TERMINATOR RESISTOR MISMATCH PROBLEM

Richard Uber

6-NOV-95

Quantum Corp.

VOLTAGE SKEW CAUSED BY COMMON MODE OFFSETS AND RESISTOR TOLERANCES

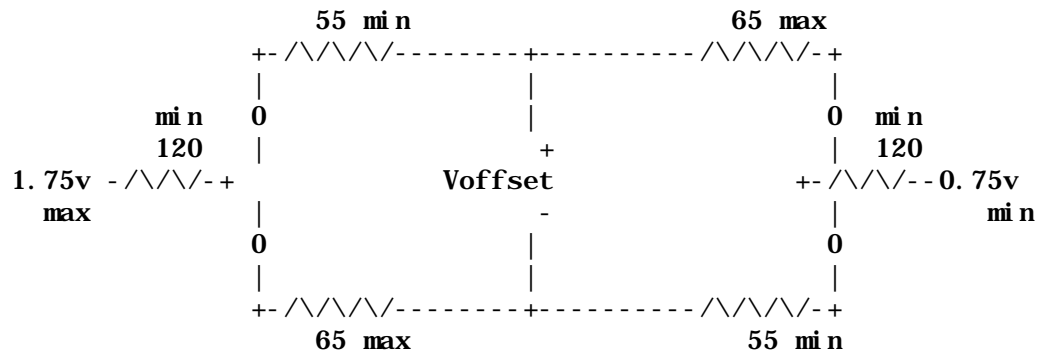
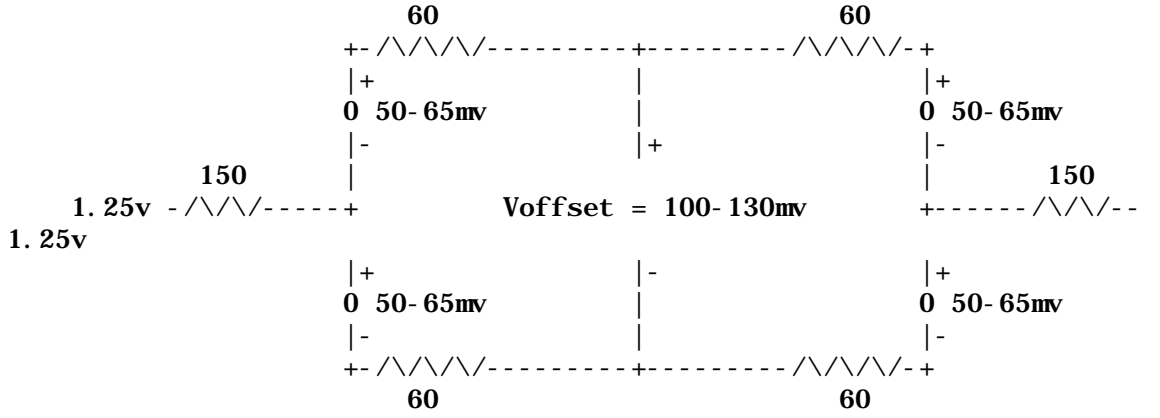
This offset can be either polarity.

- 1 A differential voltage offset of +/- 16.67mV is large relative to system noise margin of only 30mV.
- 2 On an individual terminator, the "60 ohm" resistors should match to within +/- 1-2% instead of the currently specified +/-

8.33%.

TERMINATOR MODEL PROBLEM

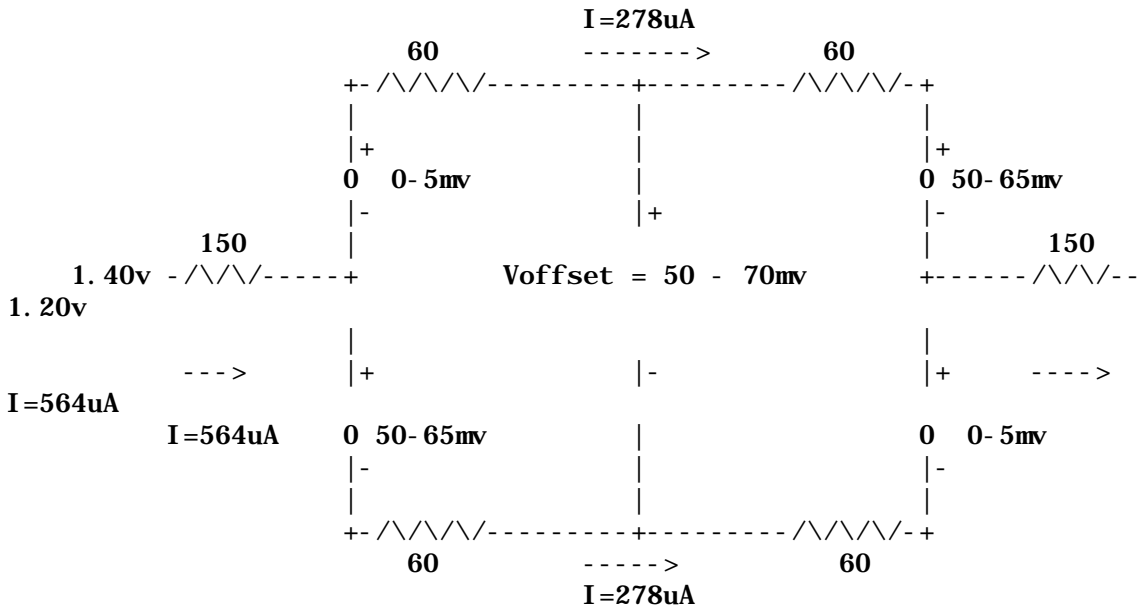
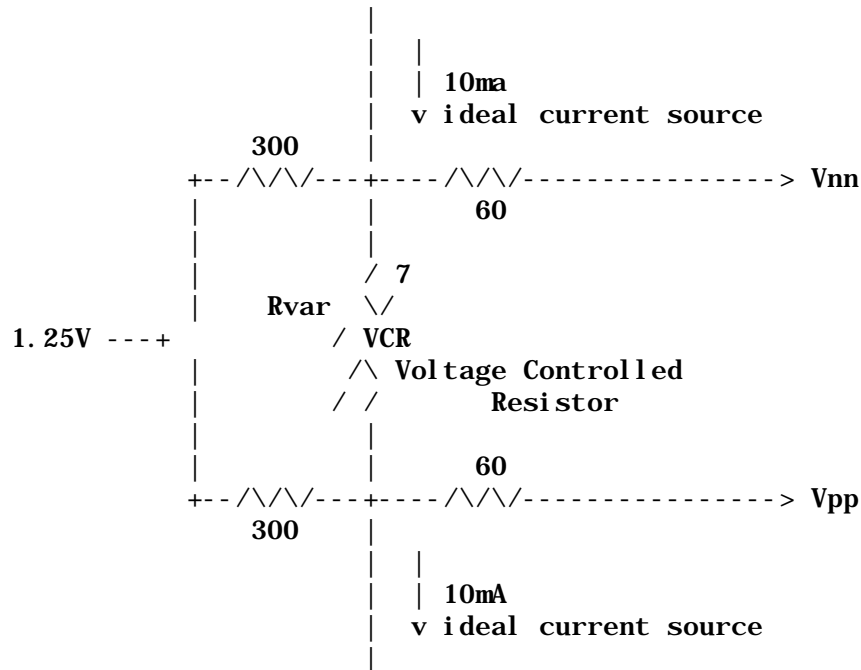
If the bias generator is modeled as an ideal zener diode as shown in the draft specifications, then the following situation develops if there is a common mode voltage difference between the terminators due to ground offset.

Because current flows between terminators and not from driver pin to driver pin, the ideal bias generators split their directions. Half of them see "negation current" and half of them see "assertion current".

THE RESULT IS THAT THE PASSIVELY NEGATED BUS SEES ONLY 50-70mV OF BIAS INSTEAD OF THE 100mV REQUIRED TO INSURE PROPER OPERATION OF THE LVDS RECEIVERS.

A BETTER TERMINATOR MODEL IS REQUIRED TO ENABLE LVDS PROTOCOL CHIP DESIGNERS TO DO BUS SIMULATIONS.

FAST-40 NOISE MARGIN CASES
Incident wave transitions

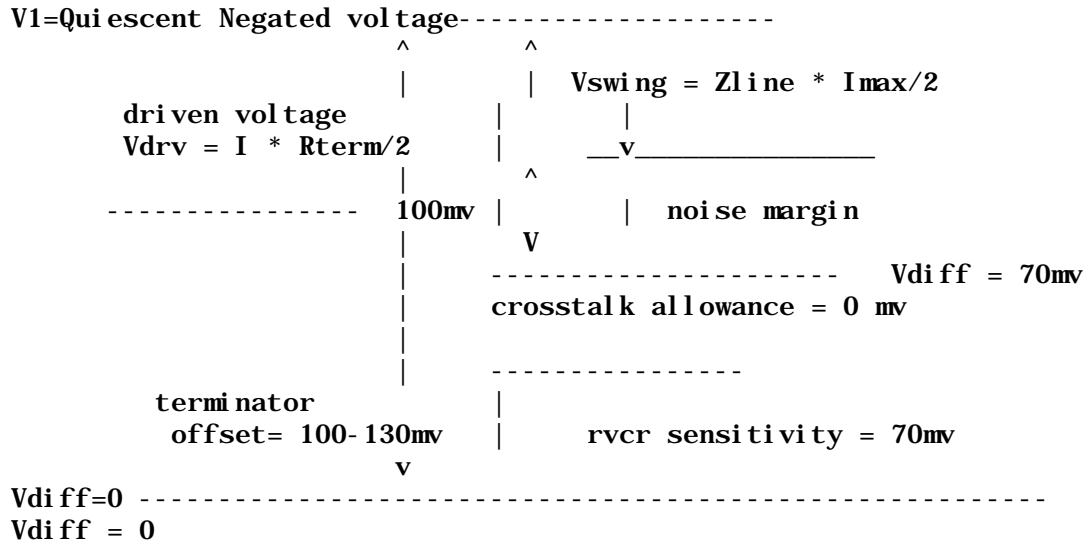
- Cable impedance needs to be limited to 110 ohms MAX.
- This is NOT compatible with current specification of 120 ohms MIN.
- We need to explore other alternatives.

4 Switch from driving current to driving voltage

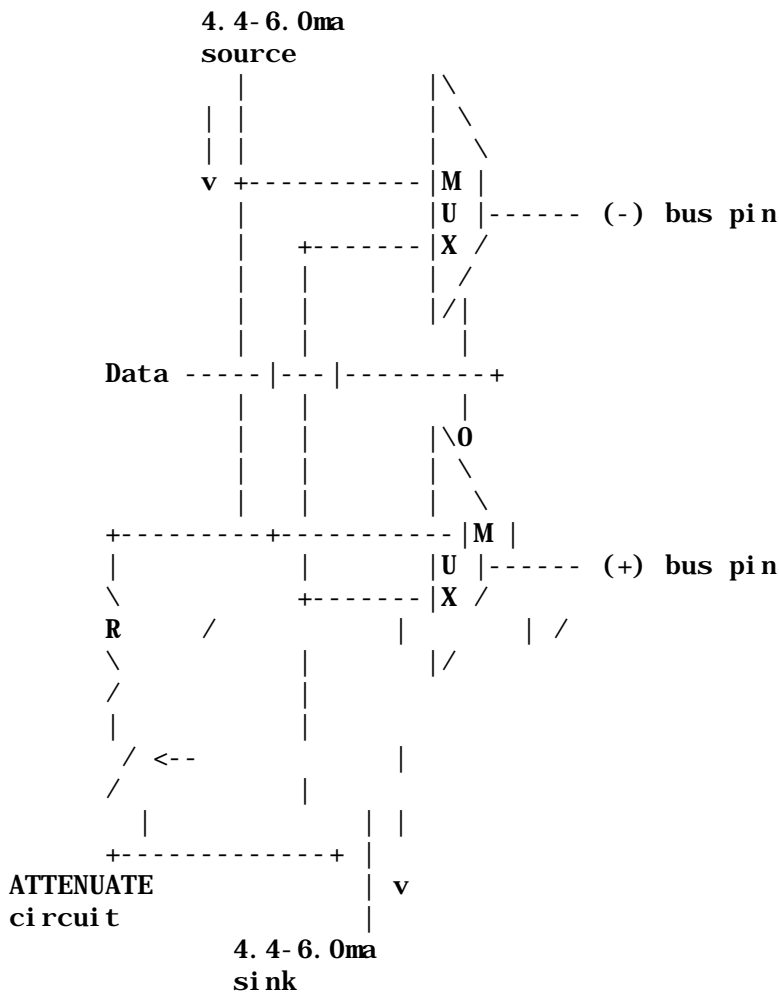
- Lessens concern with mismatches between line impedance and termination impedance.
- Can be done internal to driver, without adding any capacitance to the SCSI pin.
- The target resistance value can be in a wide range, about 100-300 ohms.
- One implementation could be:

FAST-40 NOISE MARGIN CASES
Incident wave transitions

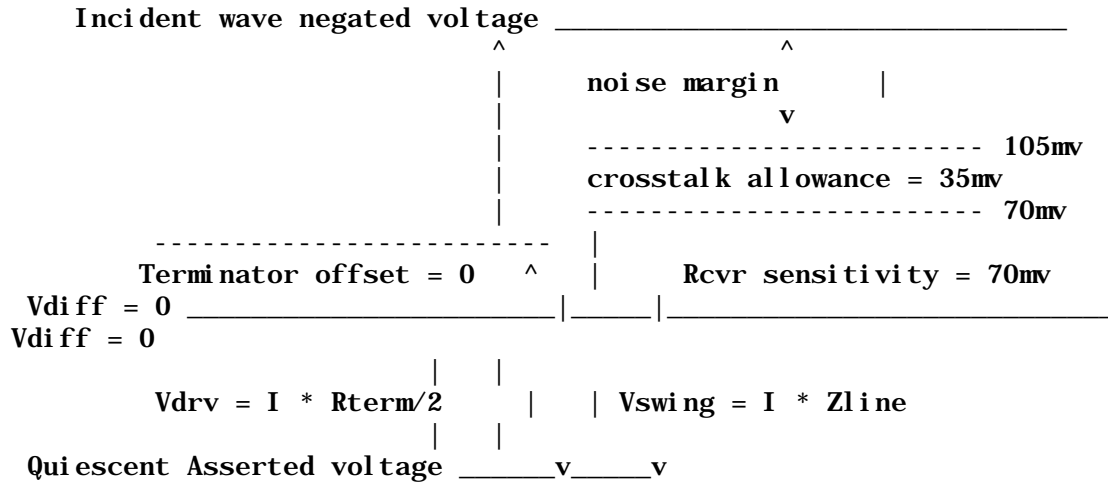
Trying larger minimum drive currents:

Trying lower termination resistances (45-55 ohms):

- Add a new state to be transitioned through when disconnecting from the bus. Connect a resistance between the positive and negative current sources. This resistance is in parallel with the transmission line, and will permit the SCSI device to exit from the LVDS bus without any assertion glitches.
- Consider lowering the termination resistance from 60 +/- 5 ohms to 50 +/- 3 ohms.
- Specify tighter matching for differential mode resistors within a terminator chip.
- Raise drive current range from 4.4 - 6.0mA to 5.0 - 7.0ma
- Limit loaded line impedance to 100 ohms minimum
